Subject: CERTIFICATE OF COMPLIANCE NO. 9292 FOR THE MODEL NO. PATRIOT PACKAGE

Enclosure 1: Description and Justification of Proposed Changes

Summary of Changes to Drawings

Figure 1 – Optional inner container lid screen

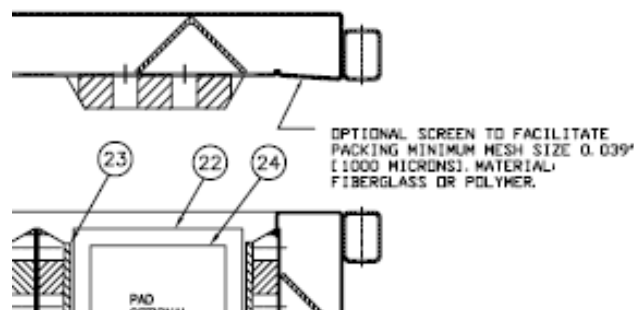
Following the completion of the first use of the refurbished Patriot packages, one additional modification to the packaging to improve the operation of the package was identified. This modification consists of adding a screen barrier to the inner container lid to keep foreign material from the fuel assembly. Also, general notes were added to describe allowed packaging configurations.

Figure 1 shows the drawing detail for the screen barrier which is to be installed on the inner container lid. The fiberglass screen material does not restrict free flow of water flow through holes in the lid. Note that this packaging configuration has been previously approved by the NRC for the RA-3, package Identification number USA/4986/AF.

SHEET 2

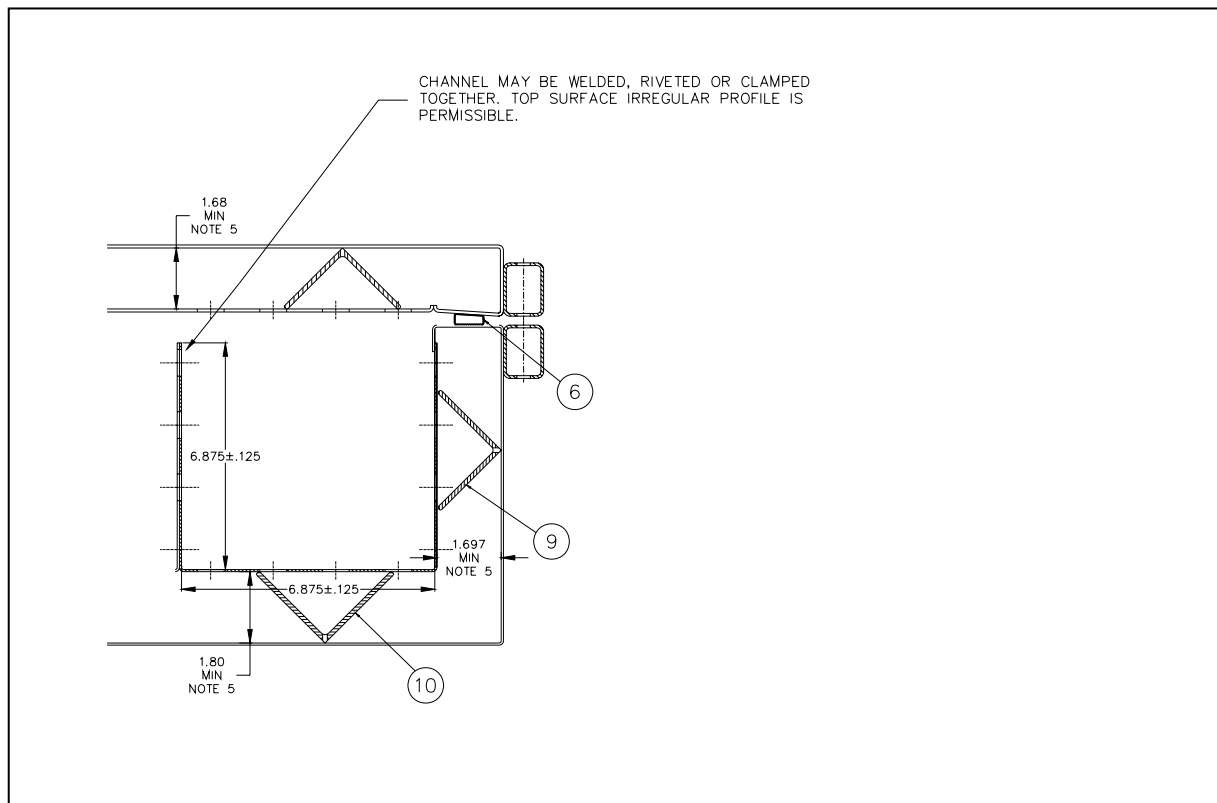
1. In Zone F6/F7, add new note to Section A-A with leader pointing to channel as shown in the sketch below:

OPTIONAL (26) DETAIL F — OPTIONAL LID END CAP
SCALE: 1/4
DIMENSIONS ADJUSTED AS REQ'D
FOR PROPER WELD FIT-UP.

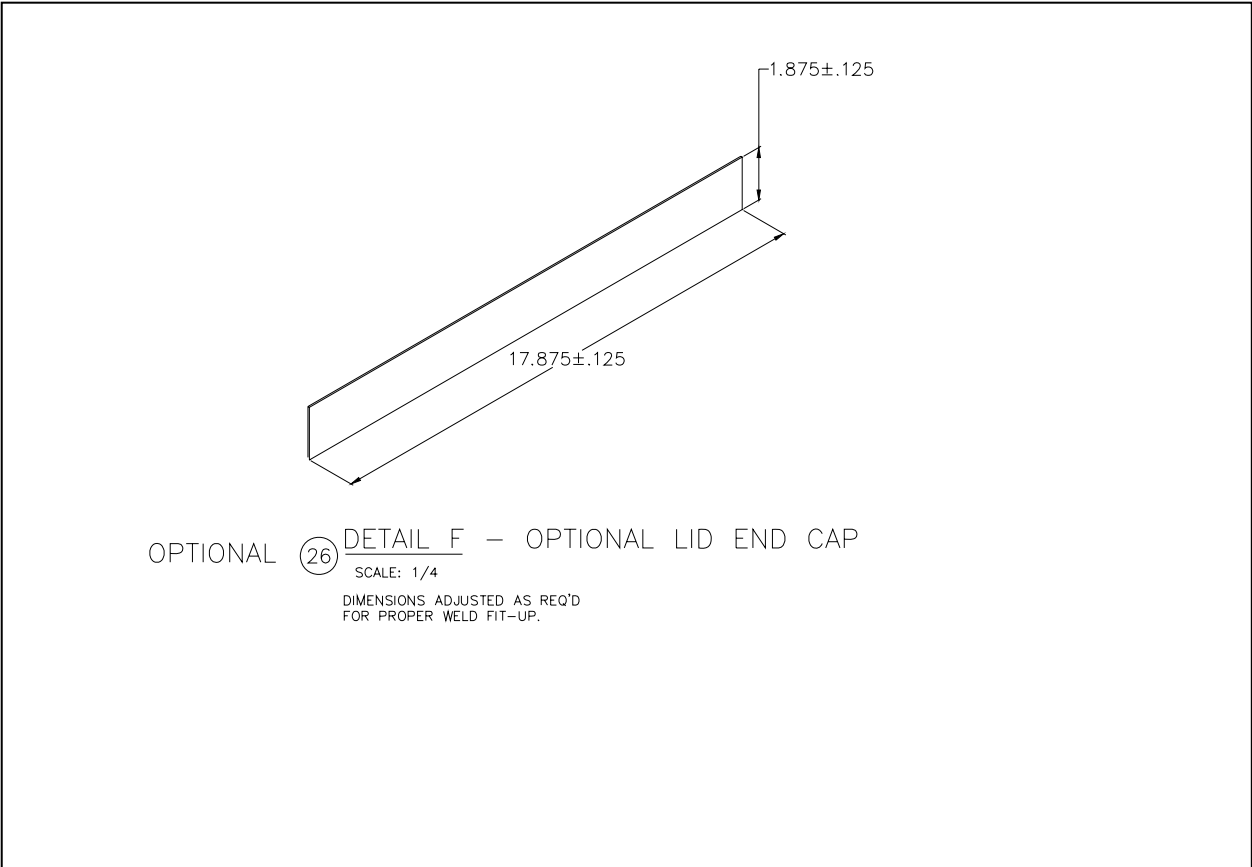
2. Add optional lid cap configuration, Detail F, near current Detail C as shown below:

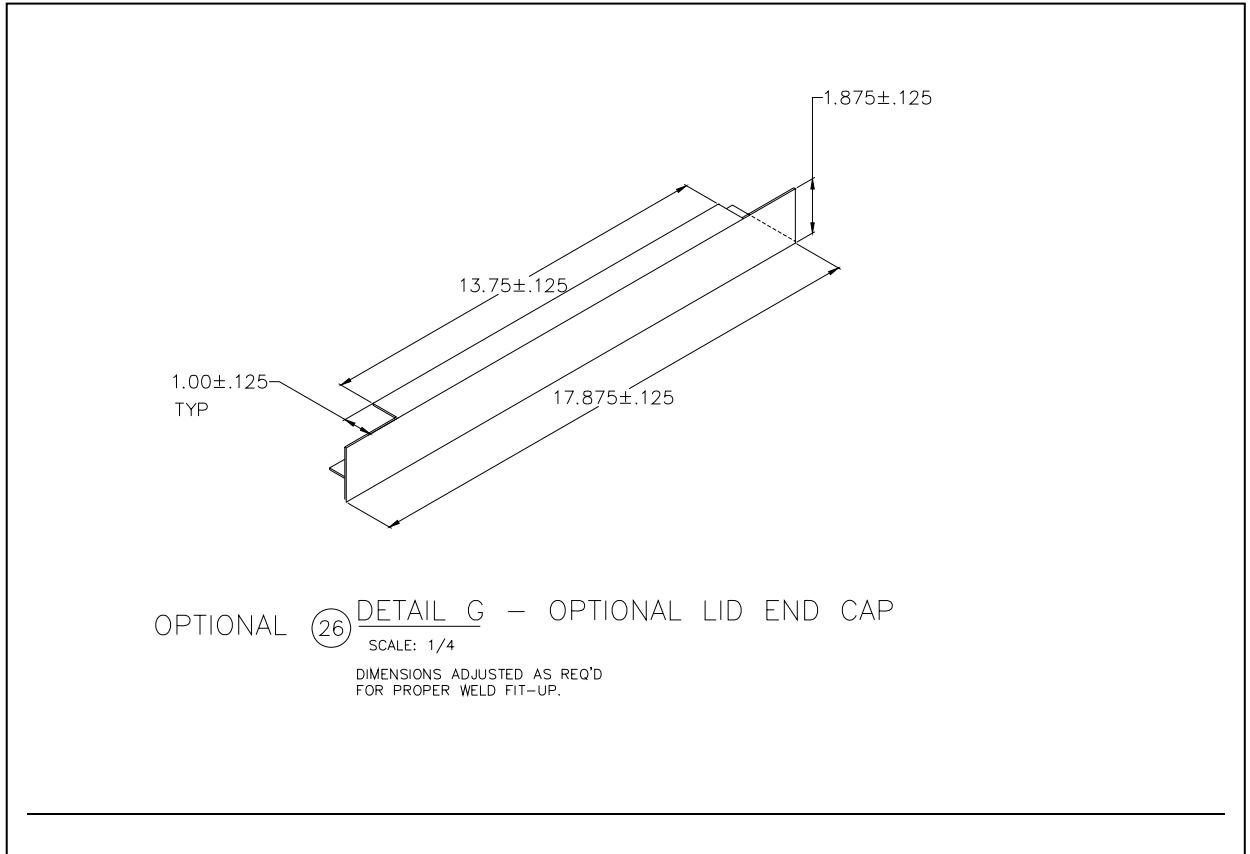
3. Add optional lid cap configuration, Detail G, near current Detail C as shown below:

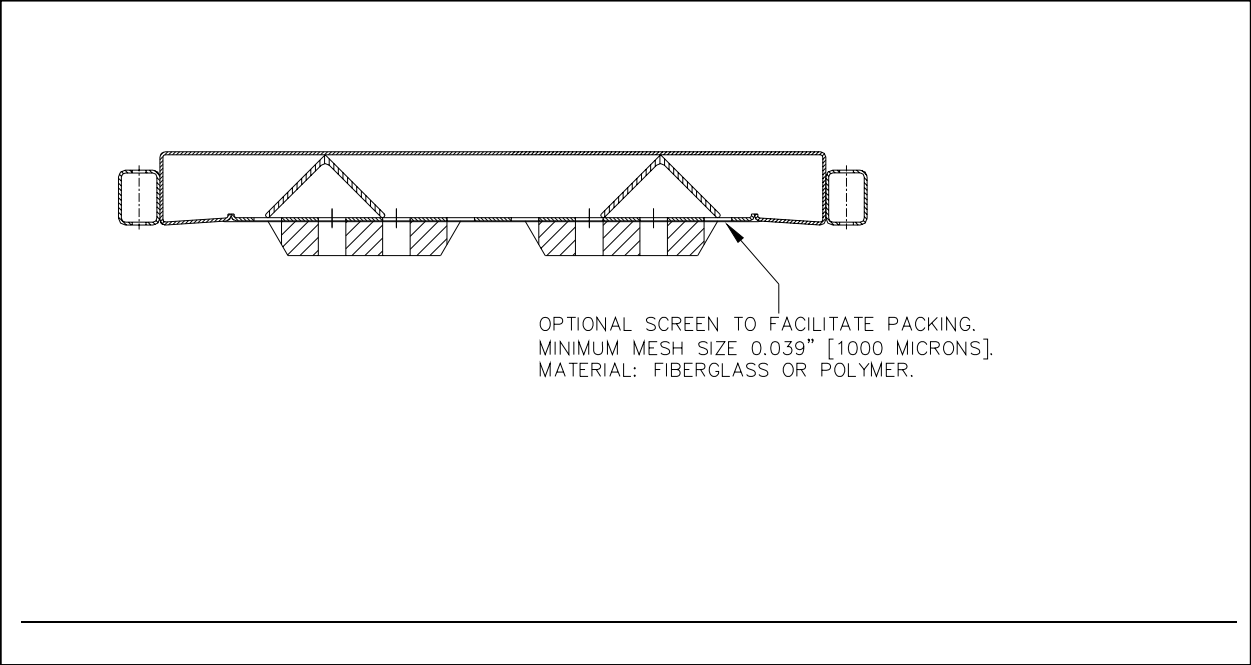
4. In Zones F3/F4 add note associated with inner box lid as shown in the sketch:

SHEET 1

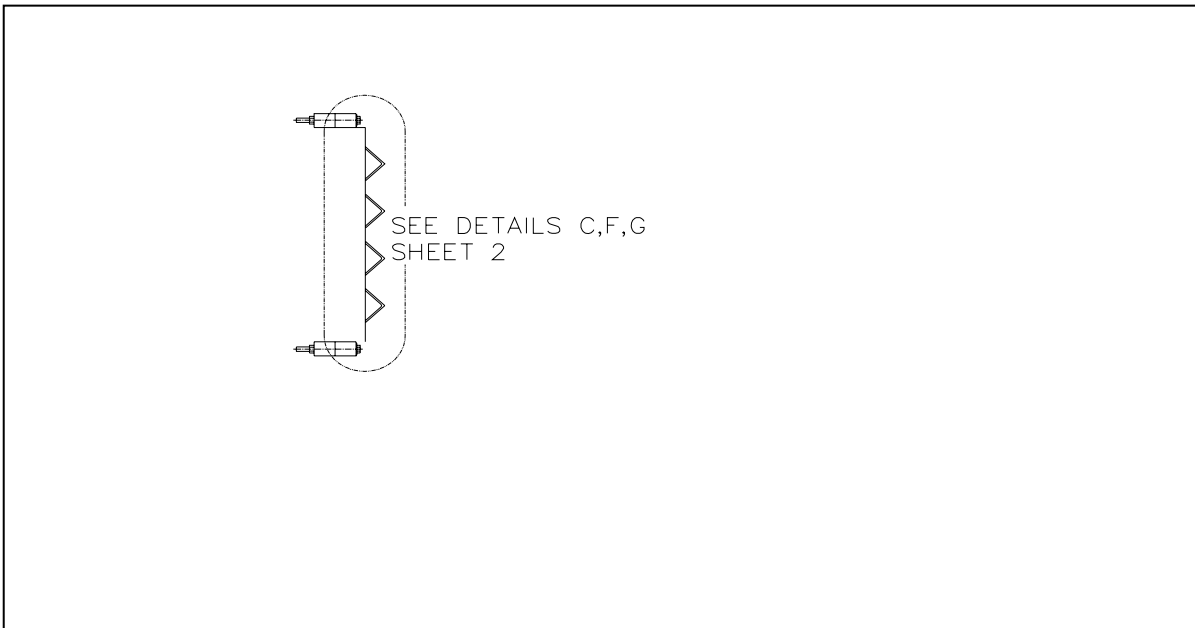
1. Remove existing note 8. Add new note 8 as follows: "FIBERGLASS OR POLYMER SCREEN MAY BE ADDED TO UNDERSIDE OF LID TO FACILITATE PACKING. MINIMUM MESH SIZE 0.039" [1000 MICRONS]. SEE SHEET 2 FOR APPROXIMATE LOCATION."
2. In Zone F4/G4, add new Detail callout to end as shown:

SHEET 2

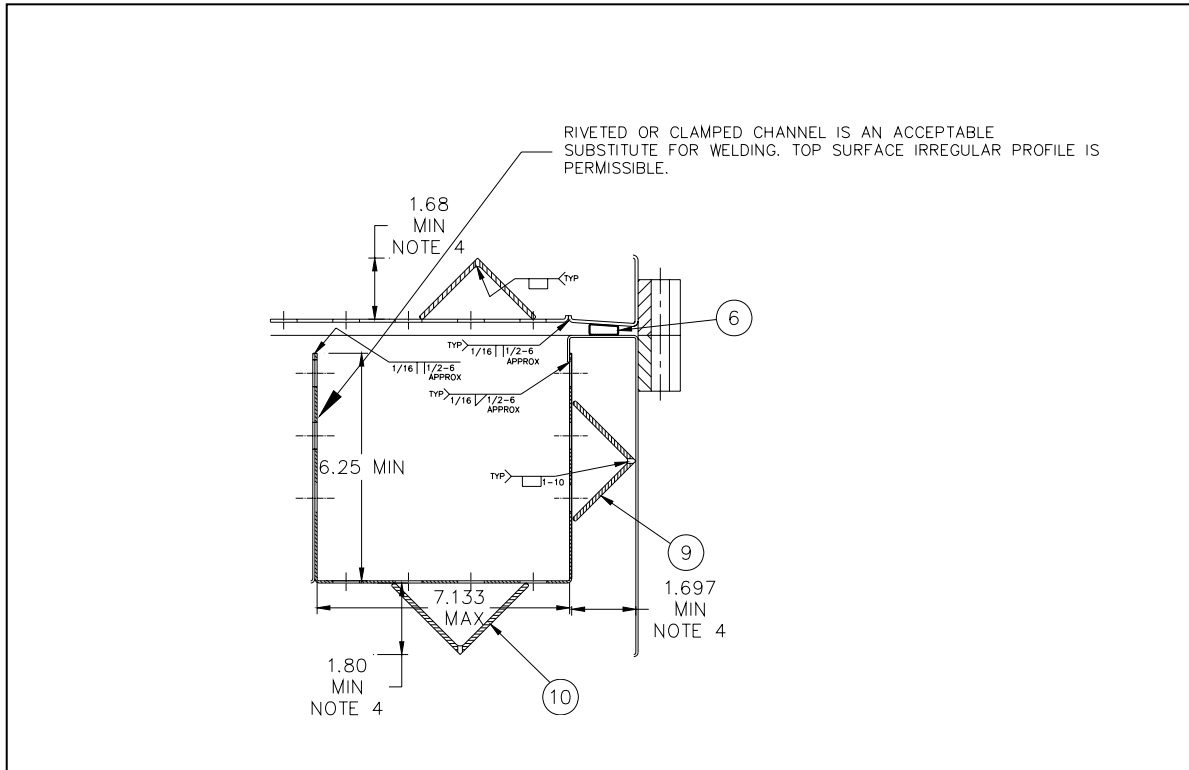
1. In Zone F5/F6, add new note to Section A-A with leader pointing to channel as shown in the sketch below:

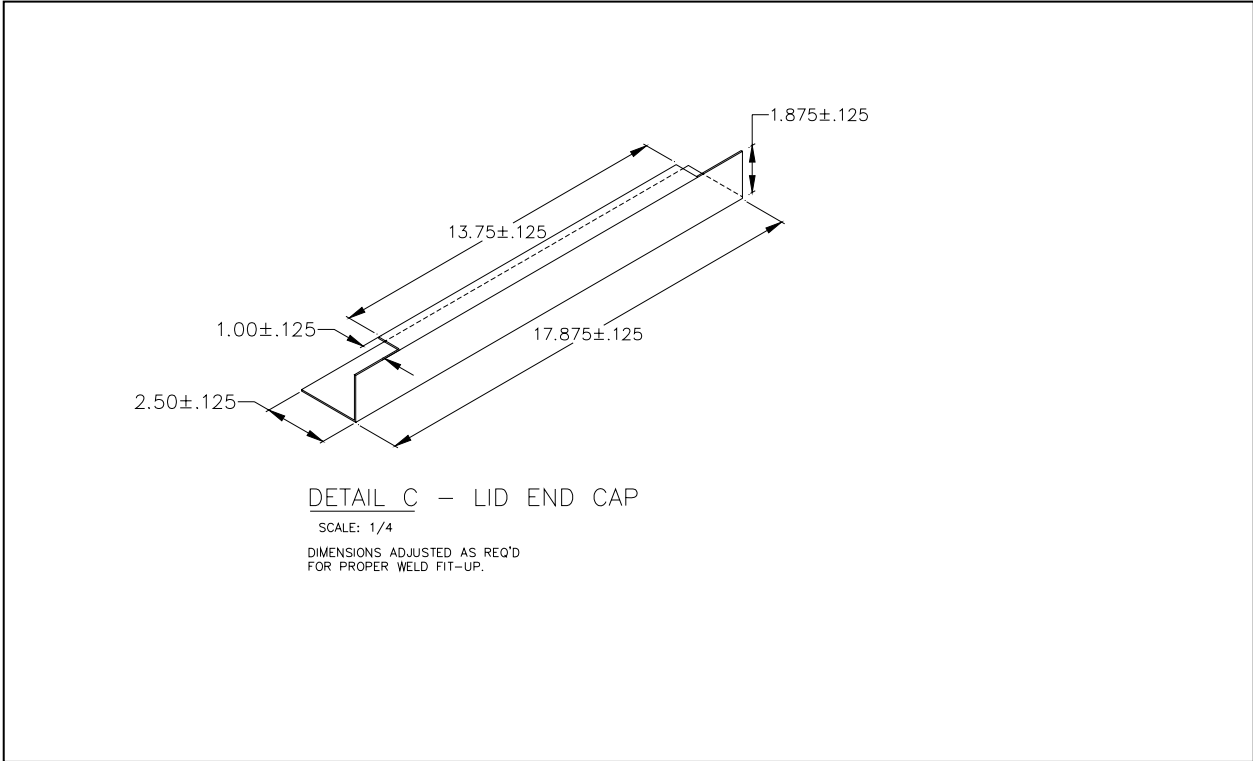
2. Add lid cap configuration, Detail C, near Zones B1-D1, as shown below:

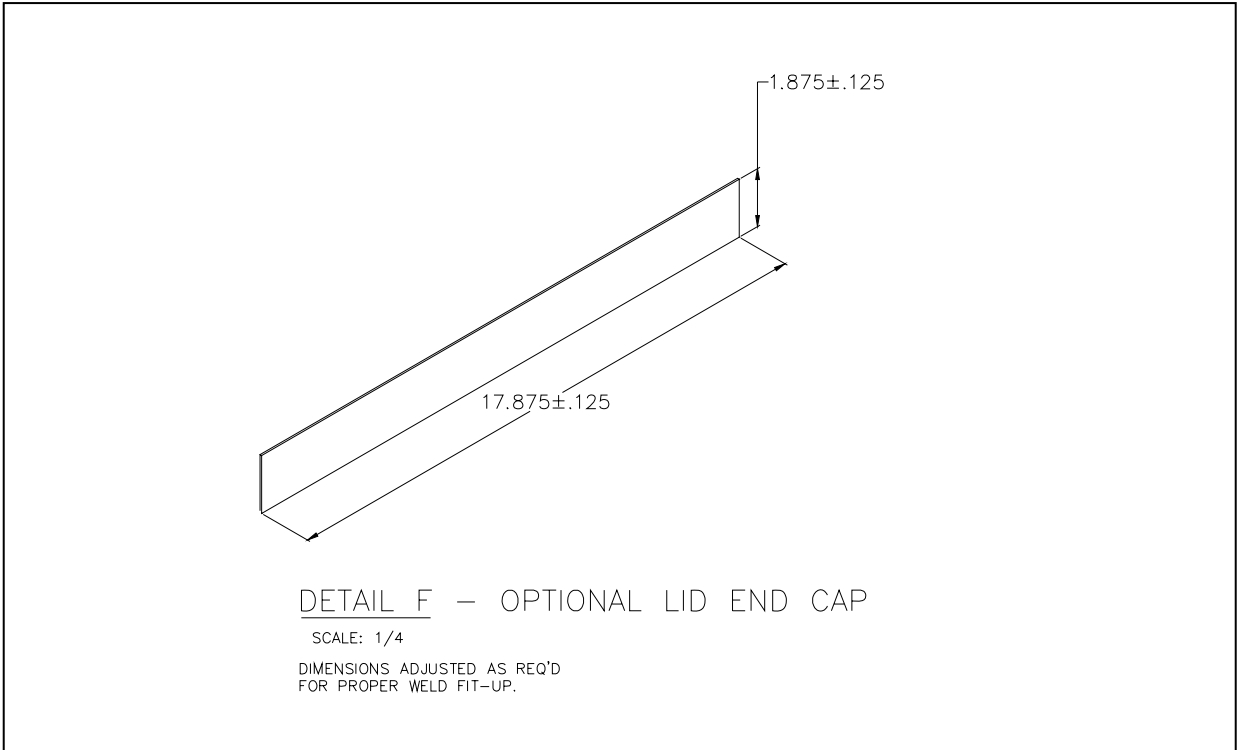
3. Add optional lid cap configuration, Detail F, near Zones B1-D1, as shown below:

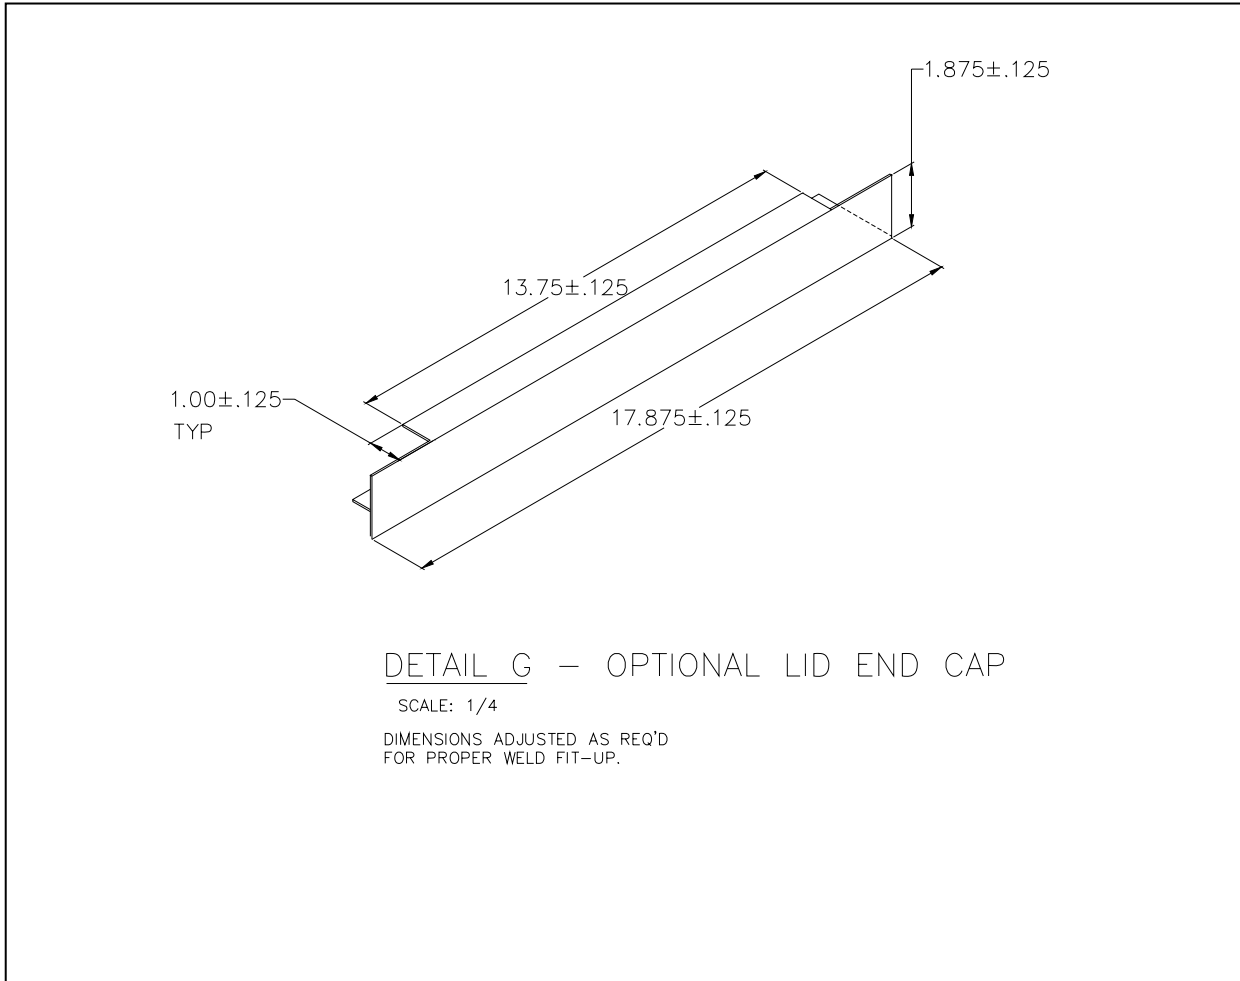
4. Add optional lid cap configuration, Detail G, near Zones B1-D1, as shown below:

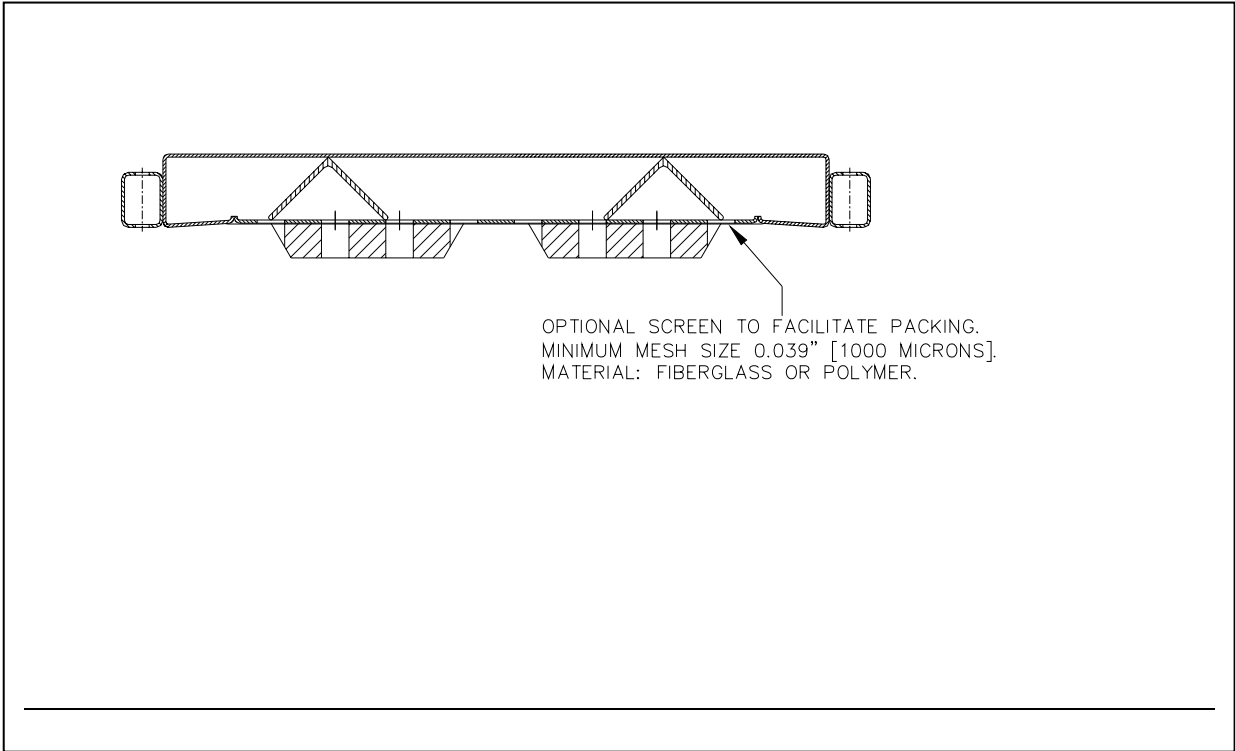
5. In Zones F2/F3 add note associated with inner box lid as shown in the sketch:
